<b>REFERENCE:</b>	<b>TSB:</b> 08-011-26 REV. A <b>GROUP:</b> 08 - Electrical	<b>Date:</b>	March 17, 2026	<b>REVISION:</b>	08-011-26
<b>VEHICLES AFFECTED:</b>	<b>2025 (WL) Jeep Grand Cherokee / Grand Cherokee L</b> This bulletin applies to vehicles equipped with a Global Telematics Box Module (Sales Code RDG).		<b>MARKET APPLICABILITY:</b> <input checked="" type="checkbox"/> NA <input type="checkbox"/> MEA <input type="checkbox"/> SA <input type="checkbox"/> IAP <input type="checkbox"/> EE <input type="checkbox"/> CH <b>NOTE:</b> This bulletin applies to the North America market.		
<b>CUSTOMER SYMPTOM:</b>	<p><b>Customers must experience a Malfunction Indicator Lamp (MIL) illumination and the vehicle must exhibit/set one or more of the following Diagnostic Trouble Codes (DTCs):</b></p> <ul style="list-style-type: none"> <li>• <b>**B1562-14 - GPS Antenna-Circuit Short To Ground Or Open.</b></li> <li>• B1561-11 - Cellular Antenna 2-Circuit Short To Ground.</li> <li>• B1560-11 - Cellular Antenna 1-Circuit Short To Ground.**</li> <li>• B22A9-96 - ECU Internal Performance-Component Internal Failure.</li> <li>• B1560-13 - Cellular Antenna 1-Circuit Open.</li> <li>• B1561-13 - Cellular Ant

**Fig. 1**  
Uconnect Box Requires Service

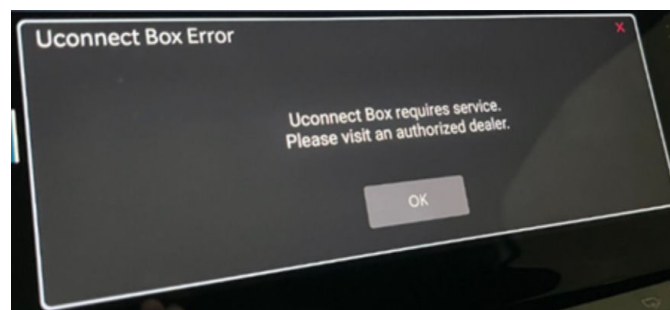
**NOTE:** This message can be triggered by different reasons **Fig. 1**. For an issue on a new vehicle recently switched to customer mode, please follow the New Vehicle Preparation procedure to resolve the issue. For the customer vehicle with intermittent concerns, please check the TBM, antenna and instrument panel harness connections.

This bulletin involves reprogramming the TBM with the latest available software.

1. Reprogram the TBM with the latest software. If issues arise when flashing a module using the wiTECH Diagnostic Application, please submit a ticket to the Helpdesk. The helpdesk can be found within the Help menu.
2. Clear all DTCs that may have been set in any module due to reprogramming. The wiTECH application will automatically present all DTCs after the flash and allow them to be cleared.
